Revised Camshaft Sprocket Bolt Torque for 1996-1999 VW/Audi 1.8L AEB Engines

Figure 1 Previously published service information for 1.8L Volkswagen/Audi 1.8L AEB engines may have incorrectly listed camshaft sprocket bolt torque at 74 ft.lbs. Correct bolt torque is 48 ft.lbs.

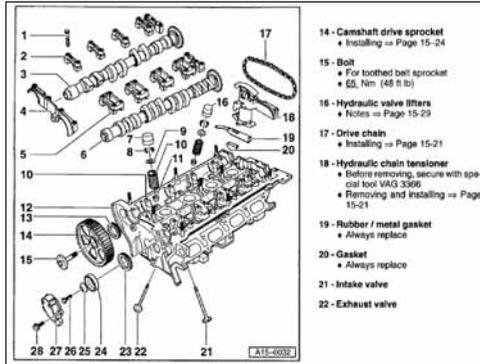
Previously published service information regarding camshaft sprocket bolt torque specifications for the 1.8L Volkswagen/Audi 1.8L AEB engines may have incorrectly listed the torque value at 74 ft.lbs.

The correct torque value for the camshaft sprocket bolt is 48 ft.lbs. (65 Nm). These cylinder heads are beginning to be seen in machine shops because many miles have accumulated since they were new.

If the incorrect torque value is used, the result may be engine failure. Even if the bolt does not break after over-torquing,

it is possible that all engine valves (20) will bend/break if the head bolts fail while engine is running (**Figure 1**, left).
